**ALAMEDA COUNTY COMMUNITY DEVELOPMENT AGENCY
PLANNING DEPARTMENT**

STAFF REPORT

PLANNING FILE #	PLN 2015-00224
OWNER	Wells Fargo
APPLICANT	SRE Development/ Mike Sullivan
PROPOSAL	Amendment of Vesting Tentative Tract Map TR-7530, and Rezone of existing PD Zoning to a PD Zoning Unit to allow construction of 21 homes reduced from 28.
LOCATION & SIZE OF PARCEL APN	4524 Crow Canyon Place, Castro Valley The project bears Assessor Parcel Numbers; 084C-1068-001, 084C-1068-007, 084C-1068-008
ZONING DISTRICT	PD (Planned Development)
GENERAL PLAN DESIGNATION	The site lies within the boundaries of the Castro Valley General Plan adopted by the County of Alameda Board of Supervisors, March 2012, designates the parcels as Rural Residential.
ENVIRONMENTAL REVIEW	The project is subject to the requirements of the California Environmental Quality Act (CEQA, 1970 as amended) and an Addendum has been prepared §15164.

UTILITY AND FIRE ACCESS PLAN
 TRACT 7530
 CASTRO VALLEY
 CALIFORNIA

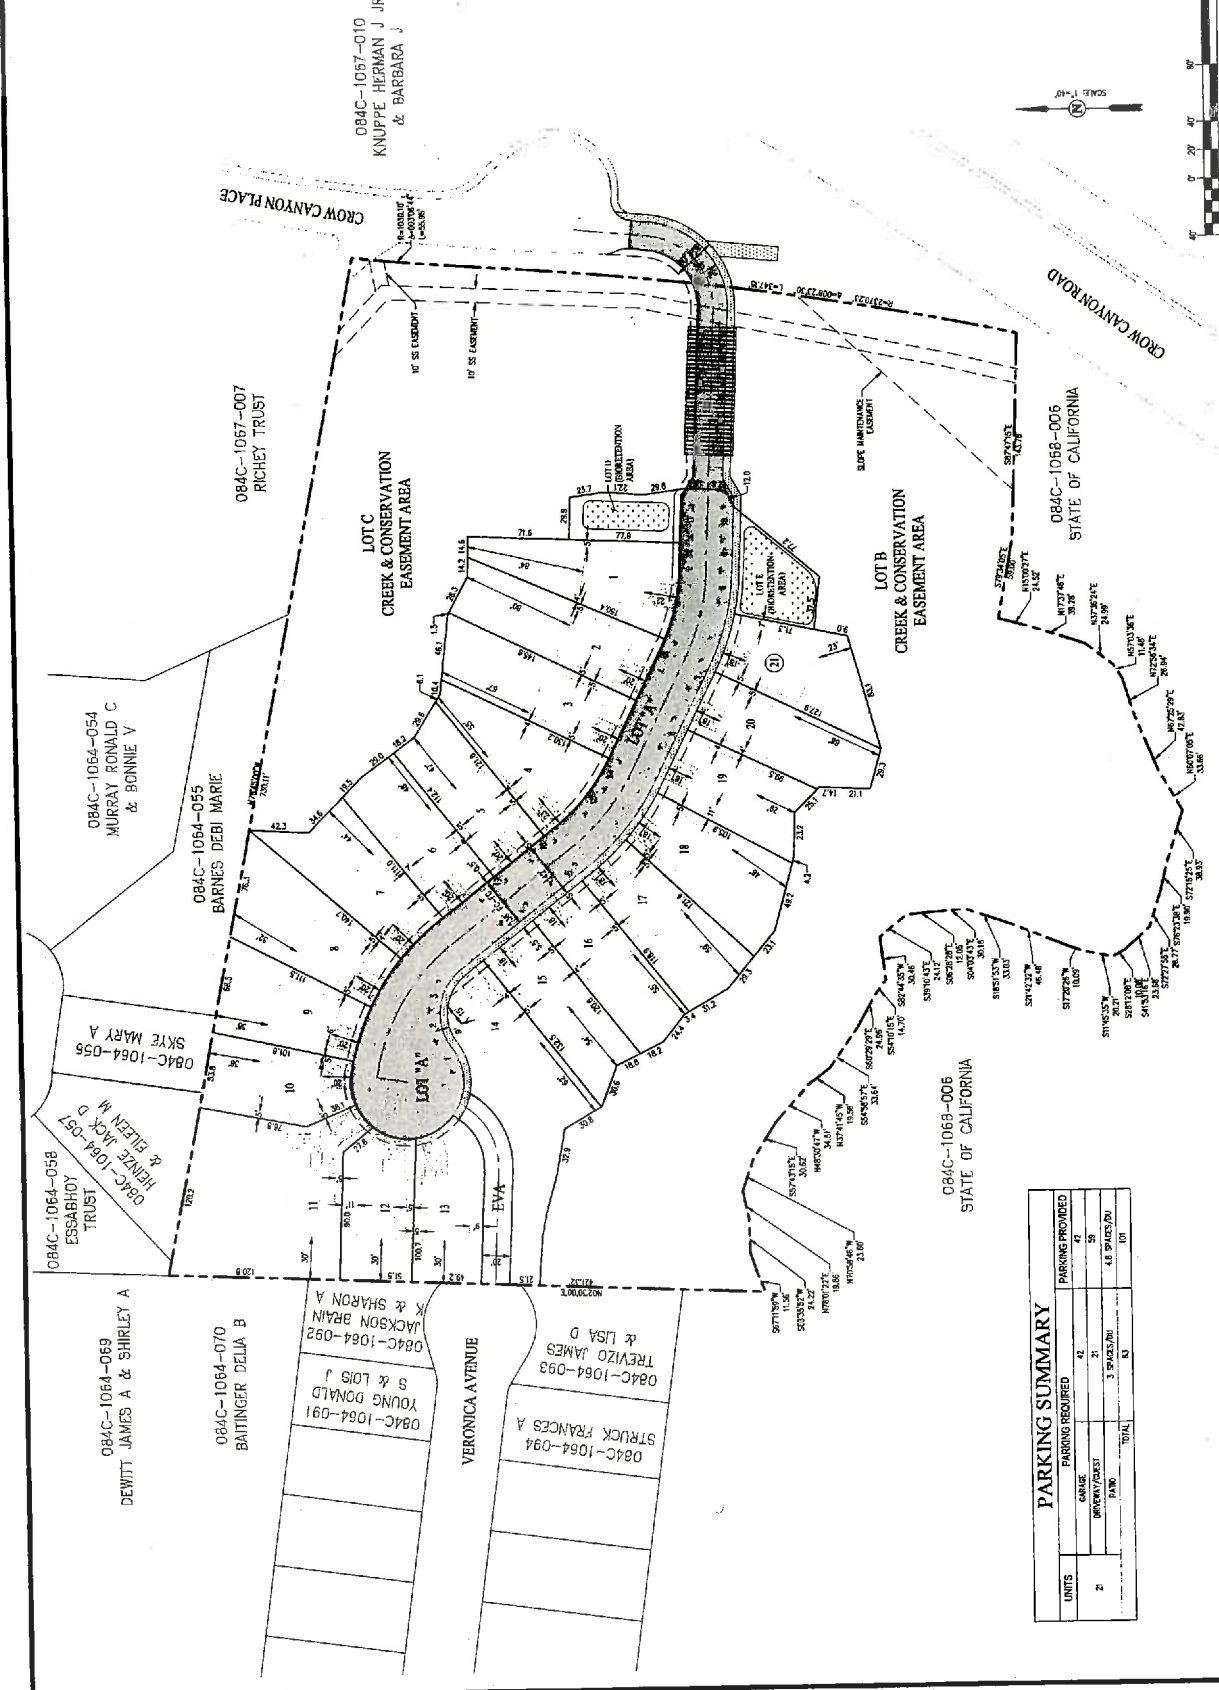
Alameda County Fire Department: On March 4, 2016, the Alameda County Fire Department indicated that the proposed project would have to cross check the previously established conditions of approval. Separately, Fire Department staff confirmed that the project site is no longer considered to be in the High Fire Severity Zone and also asked the applicant to revise the site plan to show a turning radius for fire trucks.

* BULB IS NOT A DEAD END FIRE DEPARTMENT ROADWAY. FIRE DEPARTMENT ACCESS ROADWAY CONTINUES THROUGH EMERGENCY VEHICLE ACCESS EVA.

TYPICAL ROAD SECTION NOT TO SCALE

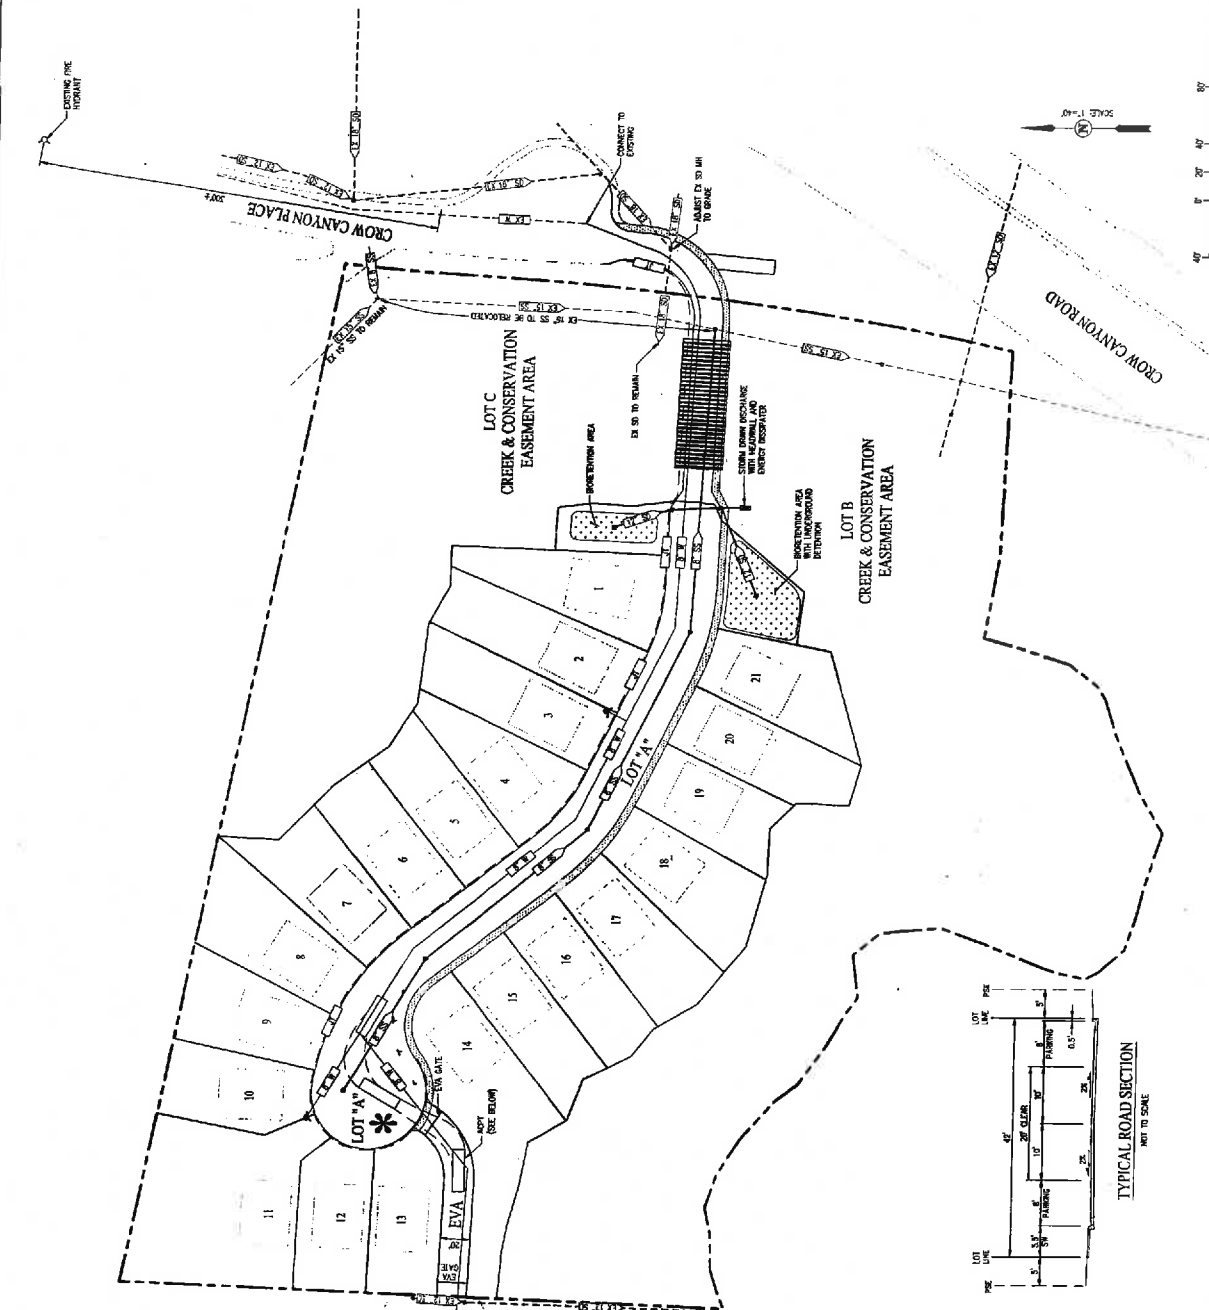
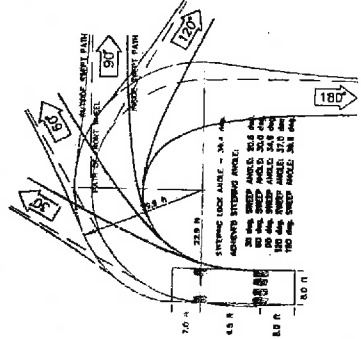
7. It will be preferable that the proposed "Section A-A, Typical 46-foot PSE" provide instead a 5-foot sidewalk from the back of curb for both sides of the road.
